Product / Process Change Notification (PCN)

<p>PCN #: PCN_UtRJ45LAN_20201118</p> <p>Affected Series: WE-UtRJ45LAN; 7498xxx; 7499xxx; S1xxx</p> <p>PCN Date: August 18, 2020</p> <p>Effective Date: November 18, 2020</p>	<p>Change Category:</p> <p><input type="checkbox"/> Equipment / Location</p> <p><input type="checkbox"/> General Data</p> <p><input checked="" type="checkbox"/> Material</p> <p><input type="checkbox"/> Process</p> <p><input checked="" type="checkbox"/> Product Design</p> <p><input type="checkbox"/> Shipping / Packaging</p> <p><input type="checkbox"/> Supplier</p> <p><input type="checkbox"/> Software</p>
<p>Contact: Product Management</p> <p>Phone: +49 (0) 7942 - 945 5001</p> <p>Fax: +49 (0) 7942 - 945 5179</p> <p>E-Mail: pcn.eisos@we-online.com</p>	<p>Data Sheet Change:</p> <p><input type="checkbox"/> Yes <input checked="" type="checkbox"/> No</p> <p>Attachment:</p> <p><input type="checkbox"/> Yes <input checked="" type="checkbox"/> No</p>

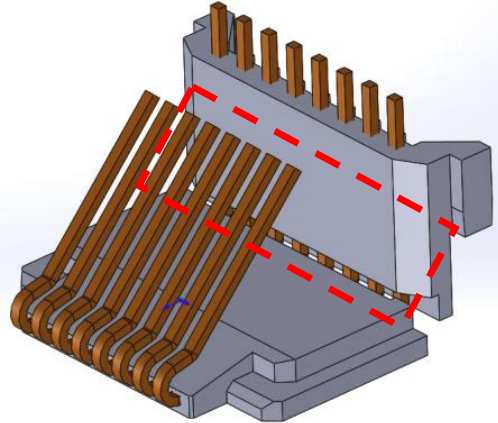
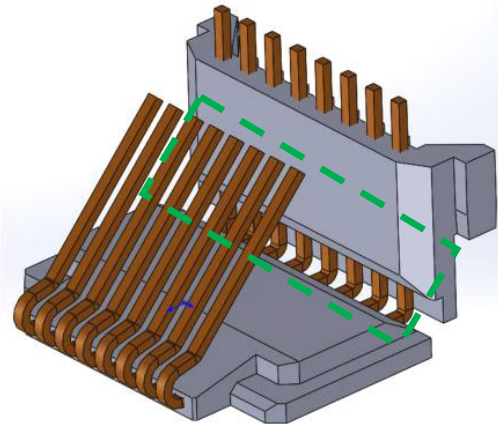
To improve the processability, Würth Elektronik will change the material of the J insert from PA46 to PA9T and improve the mechanical design.

Before Change	After Change
Plastic material: PA46	Plastic material: PA9T
